PLAN COMMISSION

AGENDA

MEMO

To: Plan Commission
 From: Adrienne Nelson, Associate Planner
 Date: January 5, 2026
 Re: CSM Review – KASD

CERTIFIED SURVEY MAP

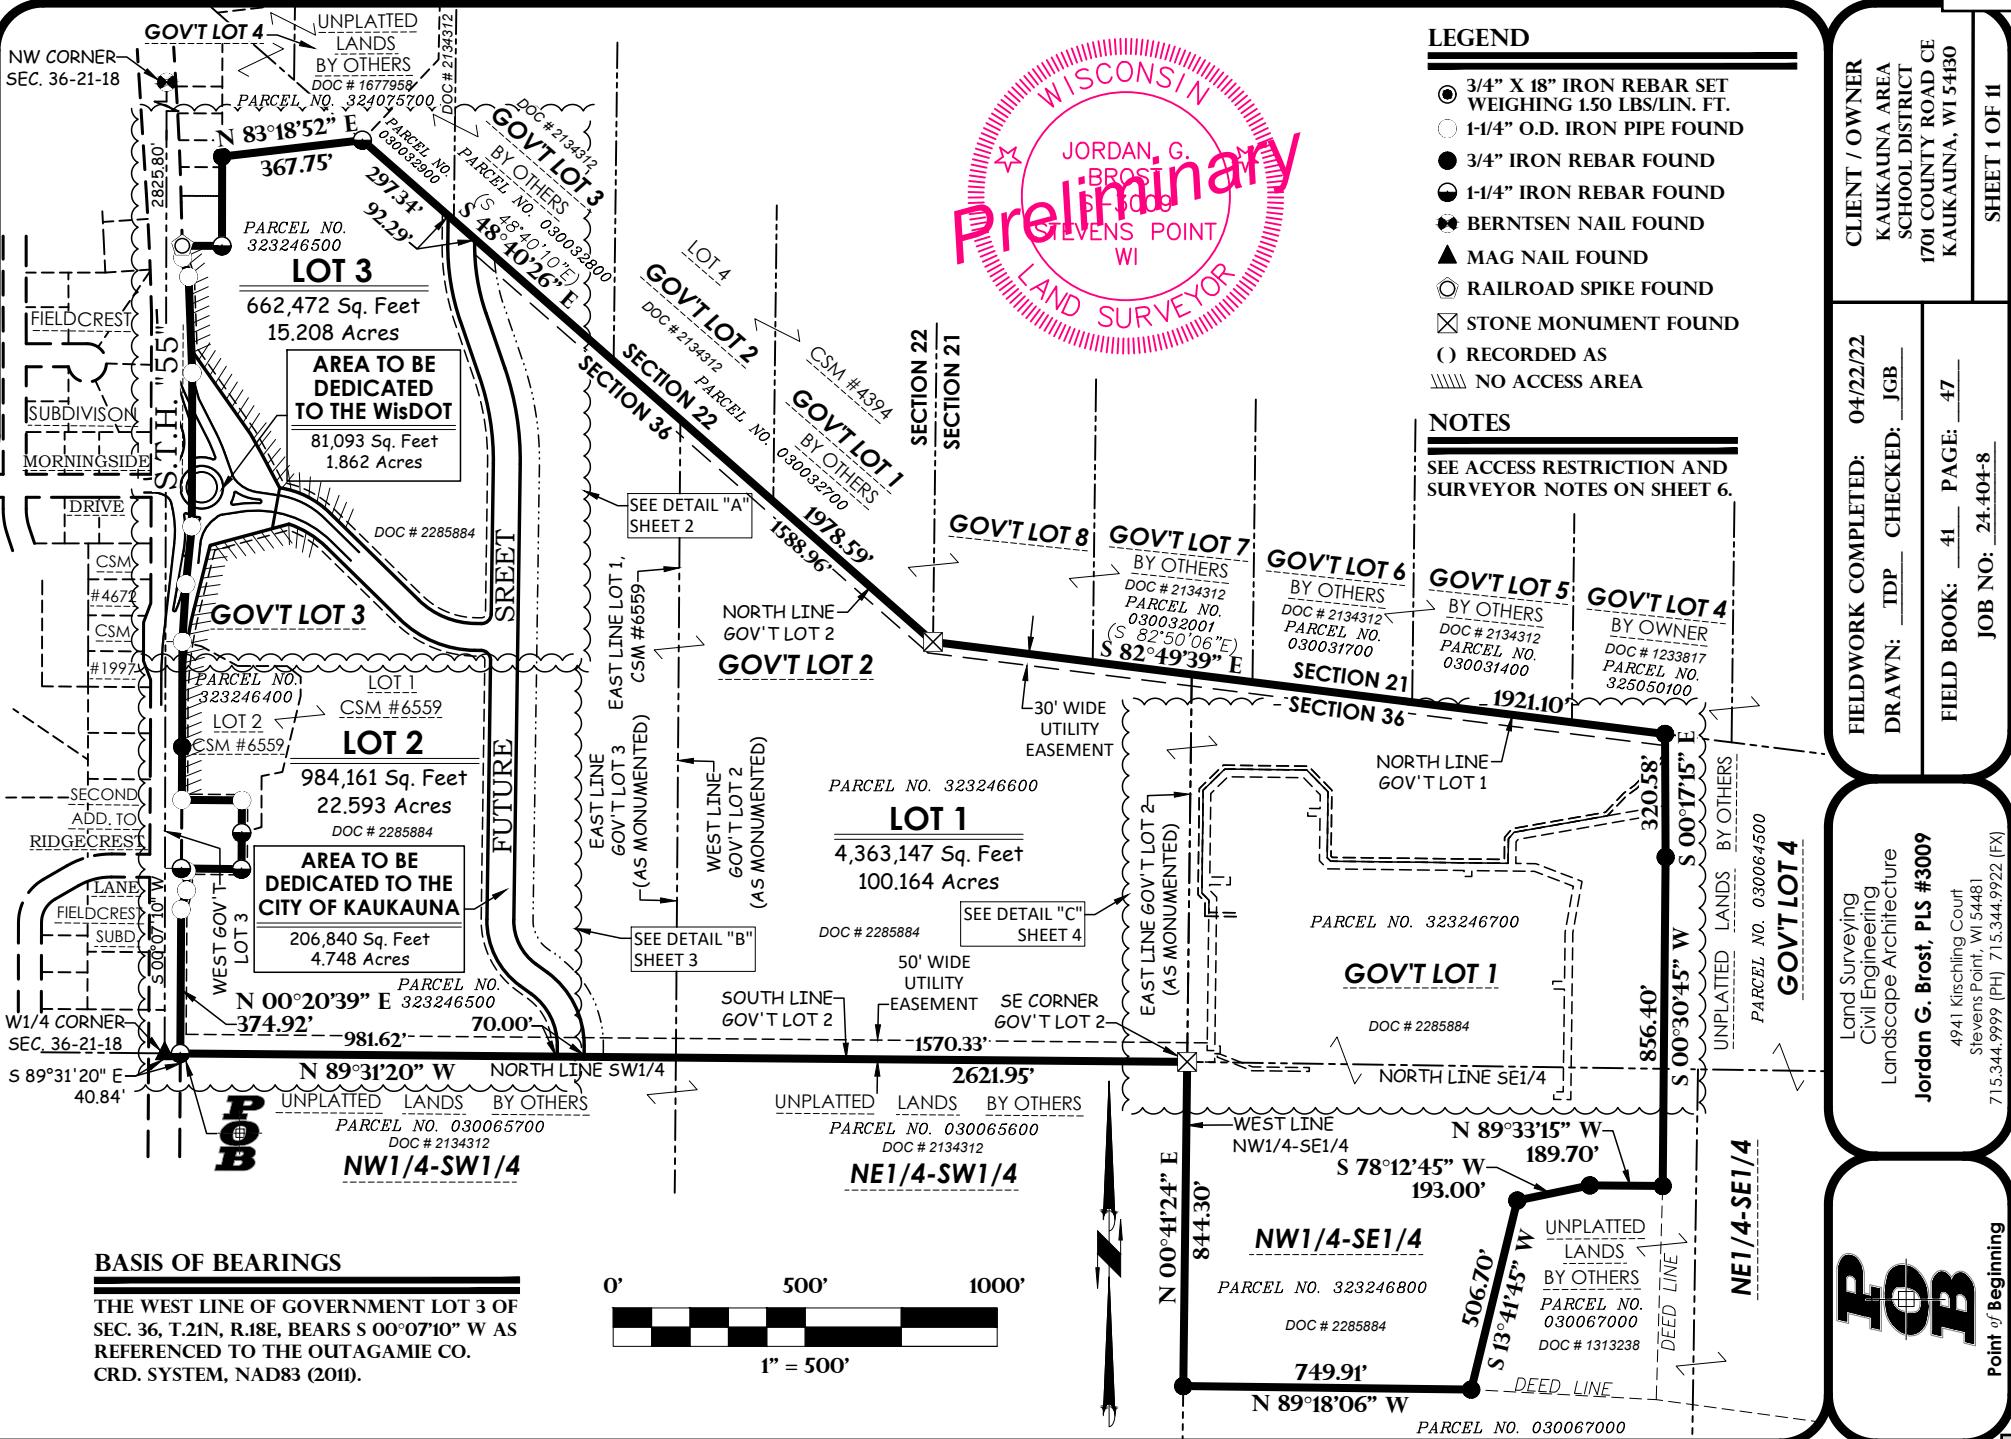
Since submission of the preliminary CSM back in September, language has been added to require an updated traffic impact study prior to the development of any vacant lots. Additionally, utility easements have been added to the final document as requested.

Recommend approval of the CSM to the Common Council with the following conditions:

- That a temporary easement for a public access or turnaround at the intersection of Speedway Lane and the new middle school road is added to the CSM.
- That final approval of utility easements is received from Kaukauna Utilities.
- That the necessary easement on parcel number 030064500, which will allow for a road connection between the middle school and high school, is recorded with Outagamie County.
